## **IFB ADDENDUM #2**

Re: IFB 2023-10 City View Towers Electrical Upgrade

This Addendum modifies and forms a part of the Bid Set documents dated December 13, 2023.

#### **Drawing E3.01 - Power Systems and Fire Alarm**

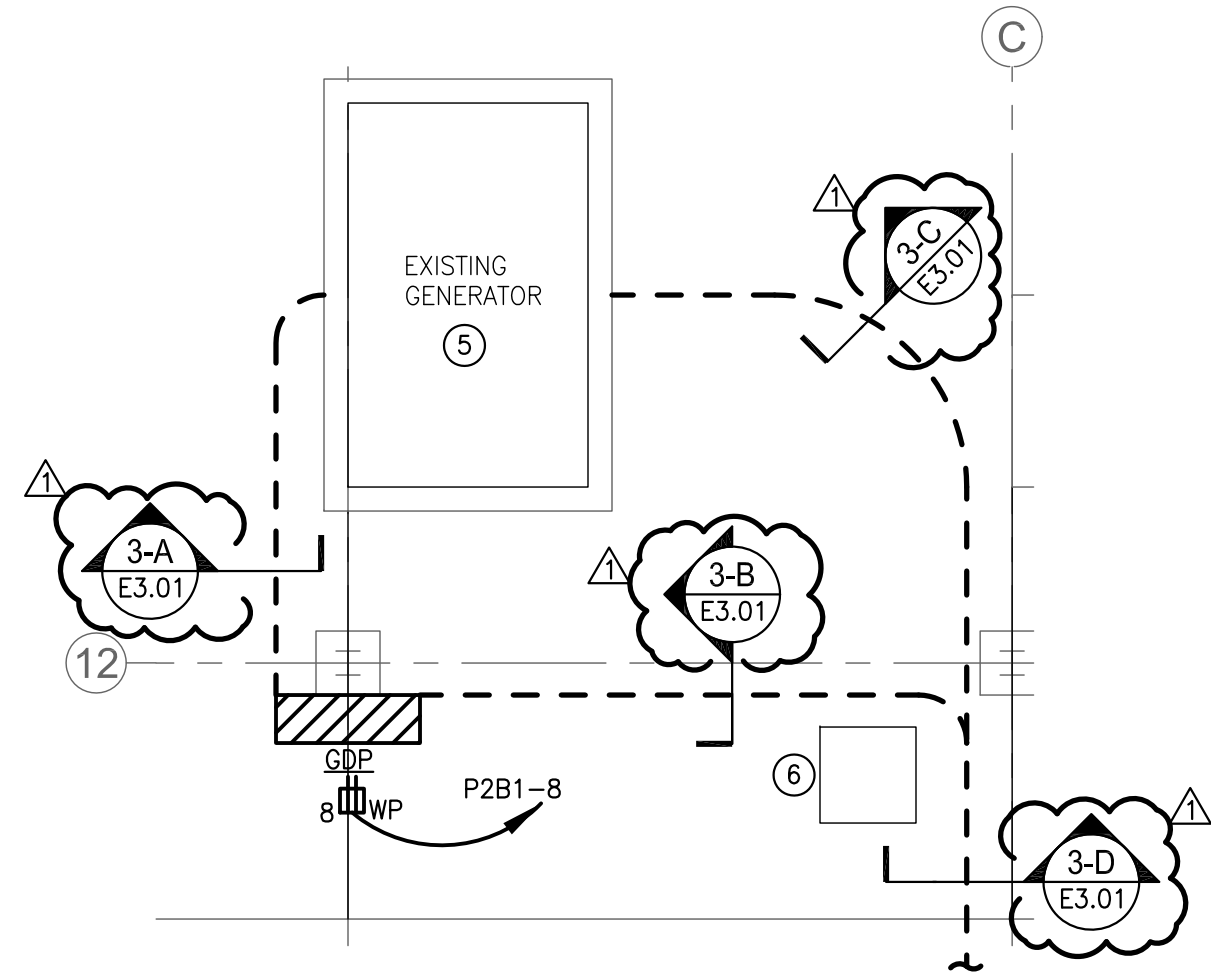
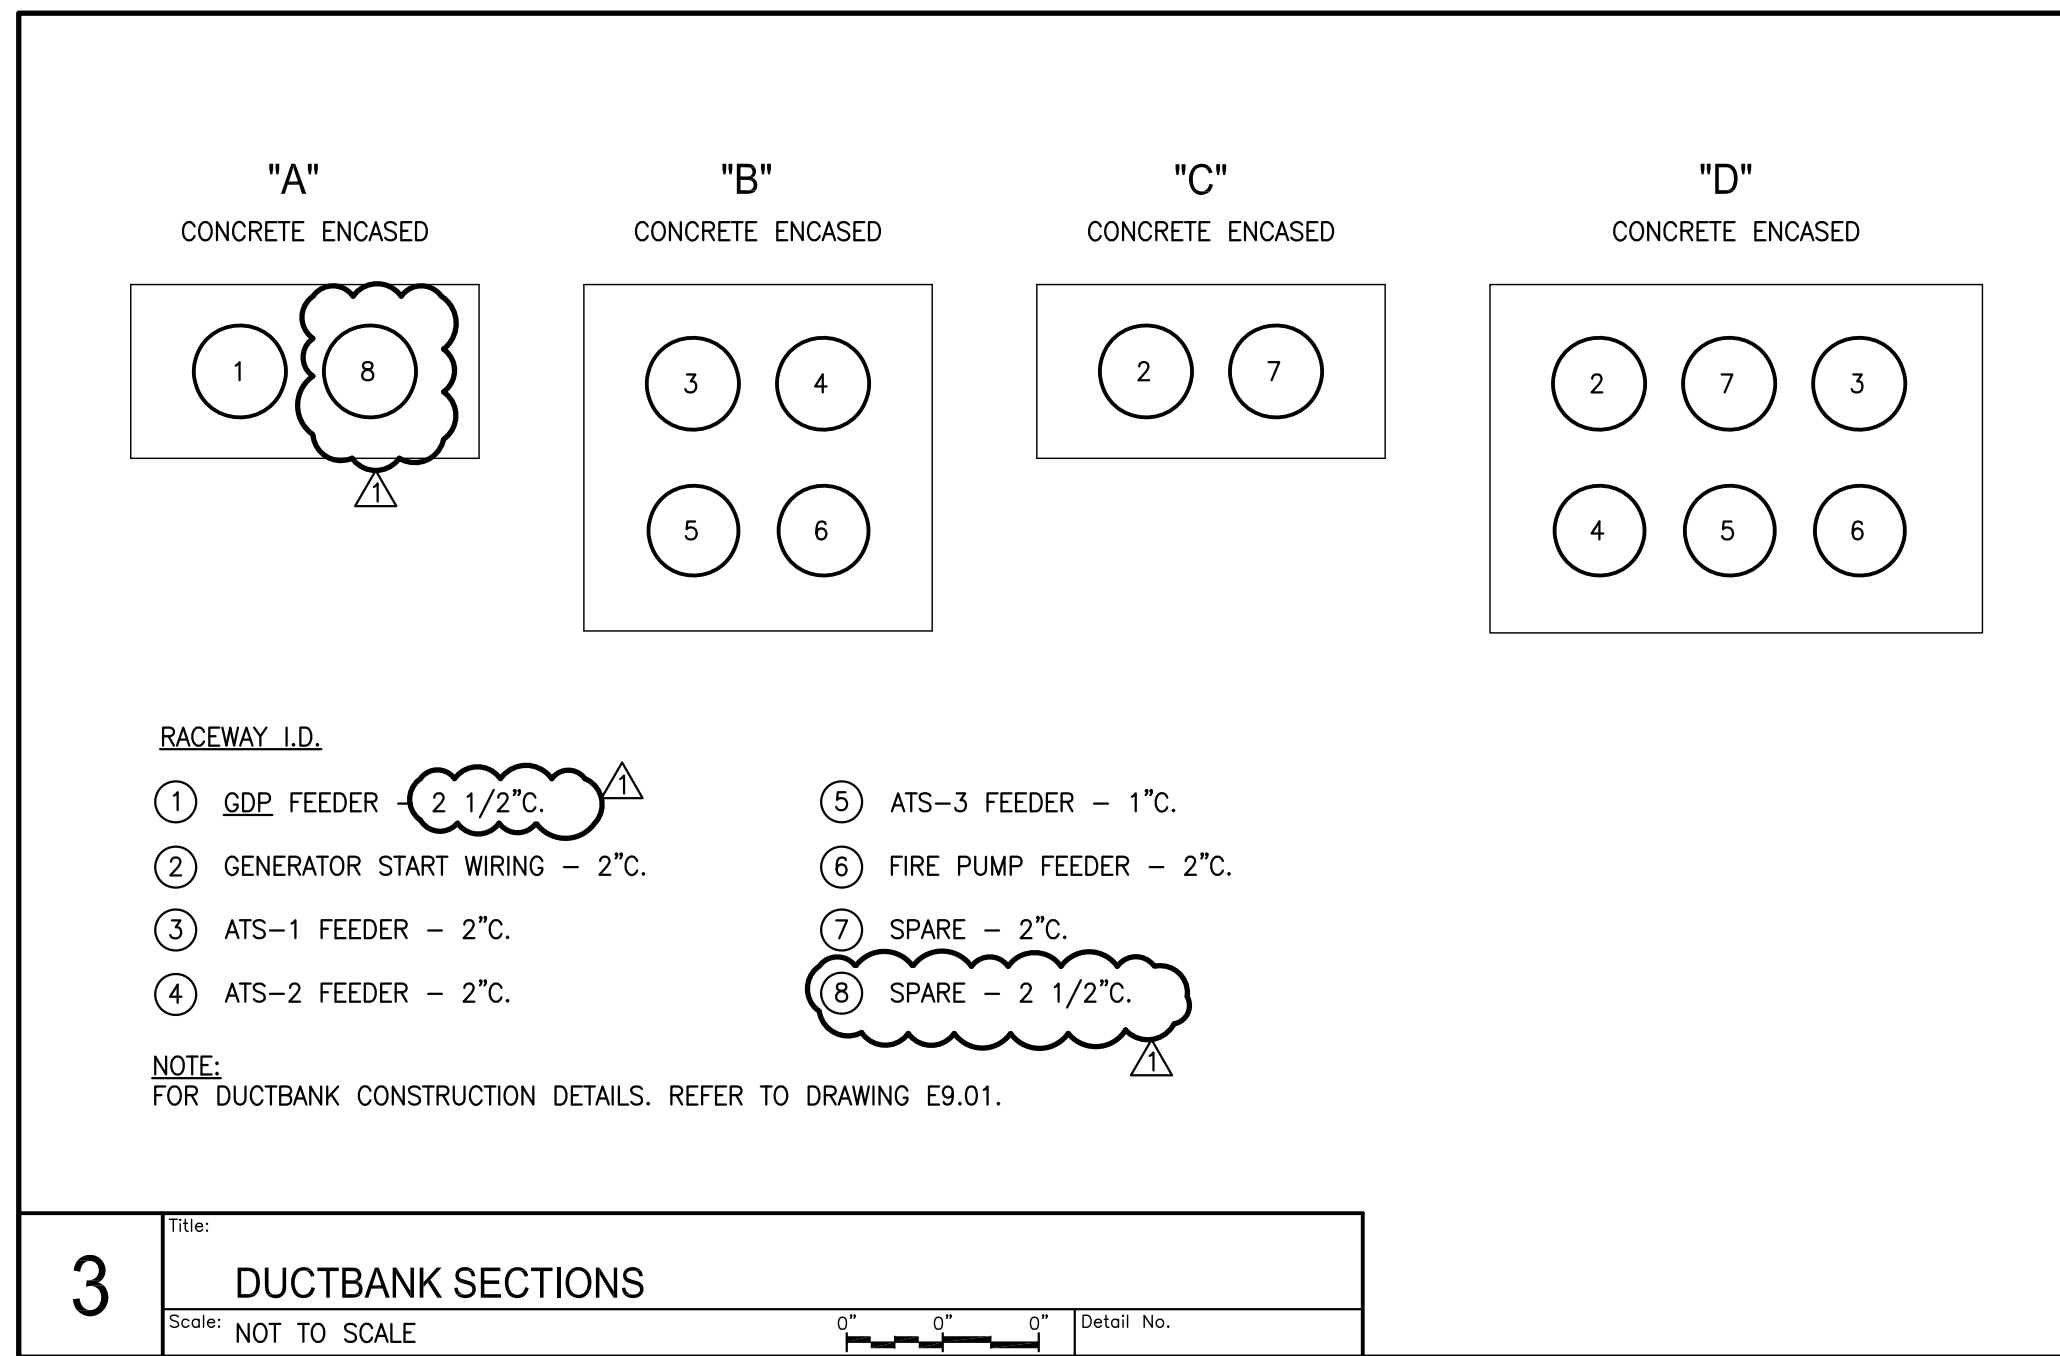
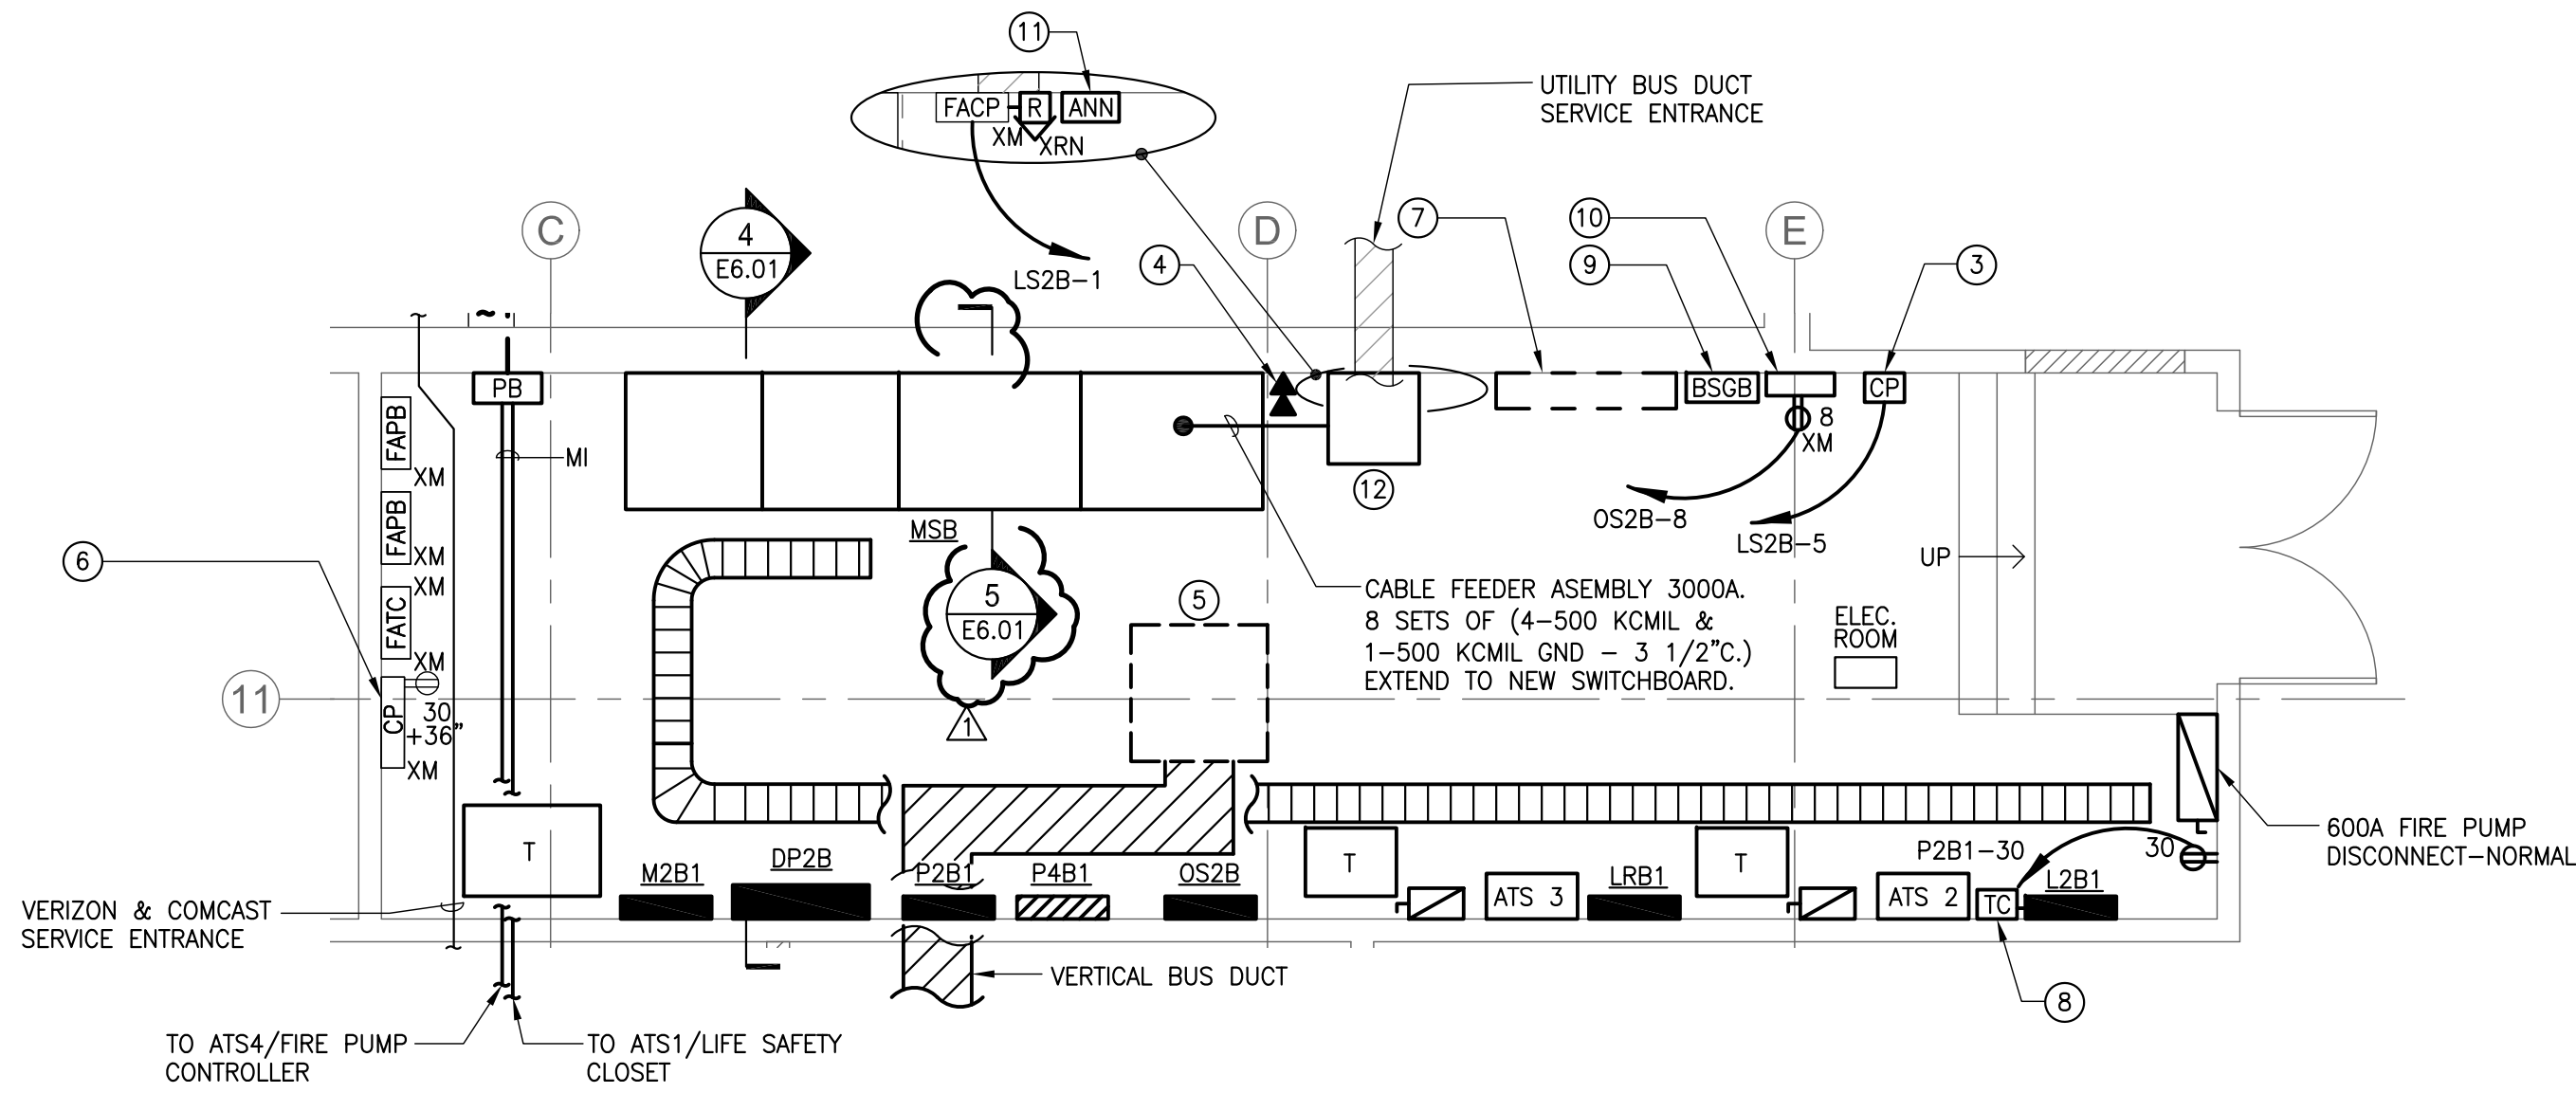
1. In Ductbank Section reference tags on Power and Systems Plan from "2" to "3".
2. In Ductbank Section - Add Tag 8 to read "Spare - 2 ½" C."
3. In Ductbank Section A - Change reference tag from "7" to "8".
4. In Ductbank Section - Change GDP feeder from 2" to 2 ½".

5 DRAIN PAN DETAIL  
SCALE: N.T.S.

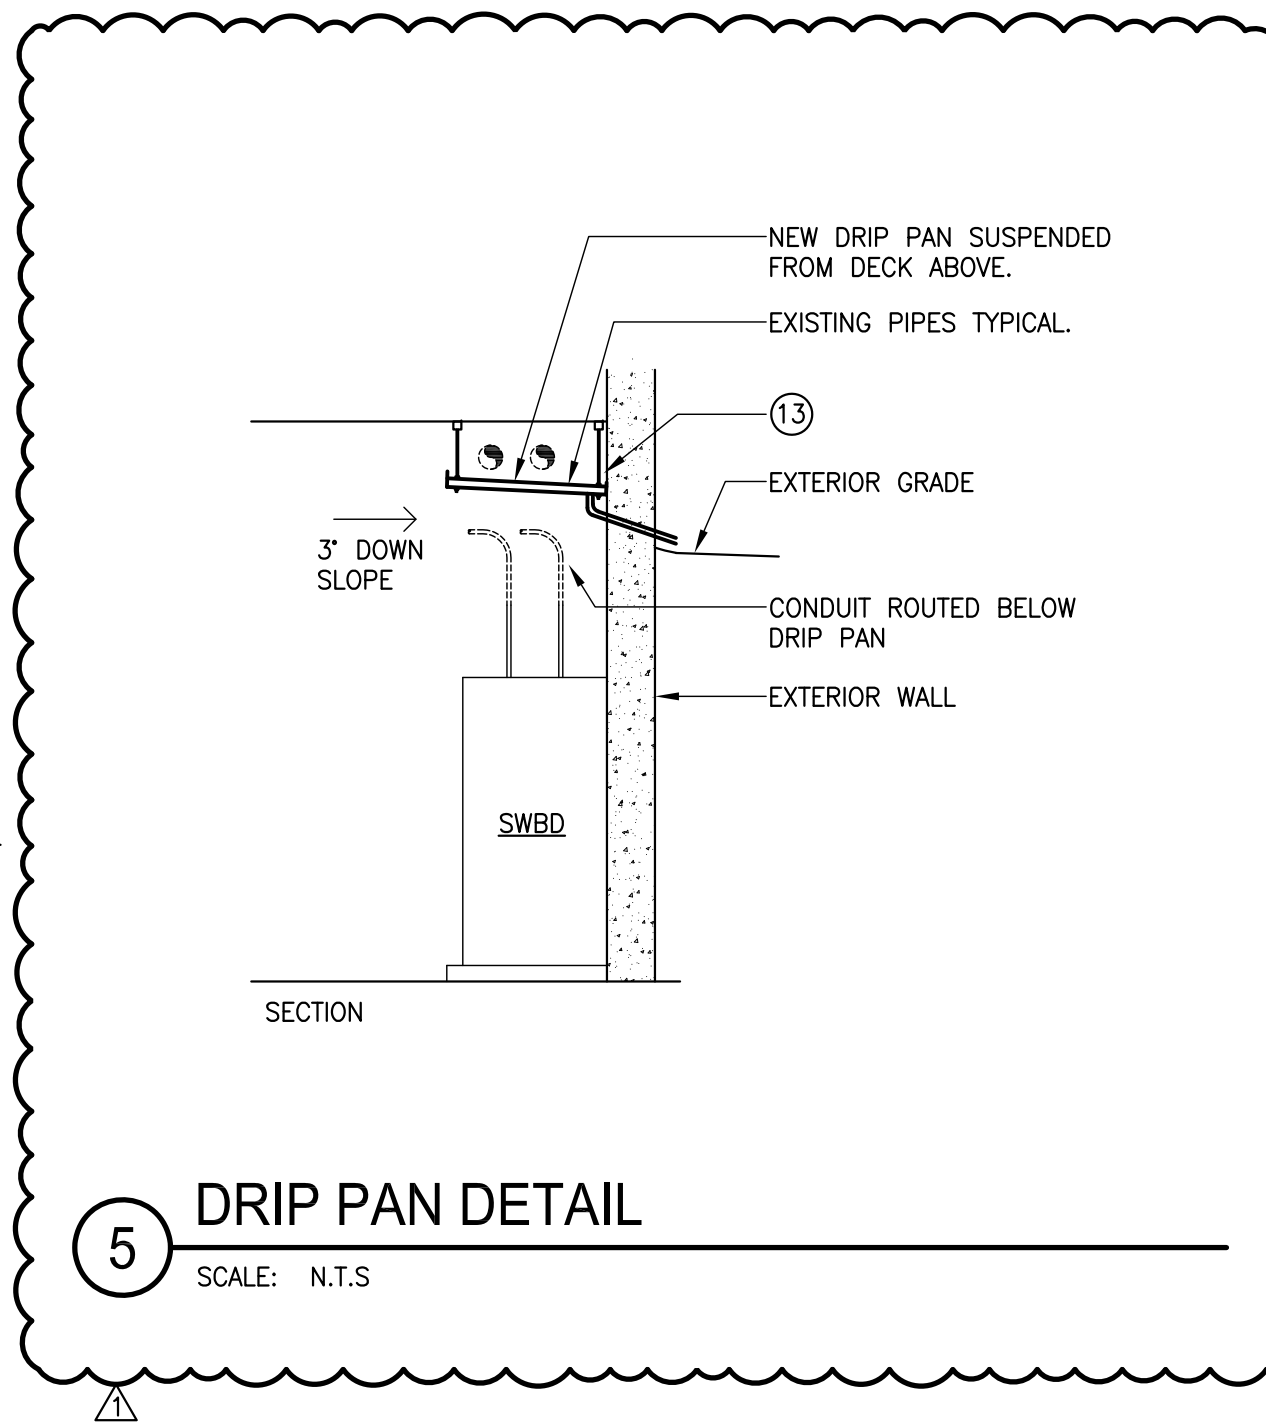
#### **Drawing E6.01 - Part Plans - New Work**

1. Add Drip Pan Detail.

- NEW DRIP PAN SIZED TO COVER THE ENTIRE SWITCHBOARD WITH 6" ON FRONT AND SIDES. DRIP PAN SIZE TO CONTAIN MINIMUM OF THREE (3) GALLONS OF LIQUID. DRIP PAN SHALL HAVE DRAIN LOCATED ON LOWEST MOUNTED OVERHANG AND PIPED TO OUTSIDE OF EXTERIOR WALL. CORING WILL BE NECESSARY.
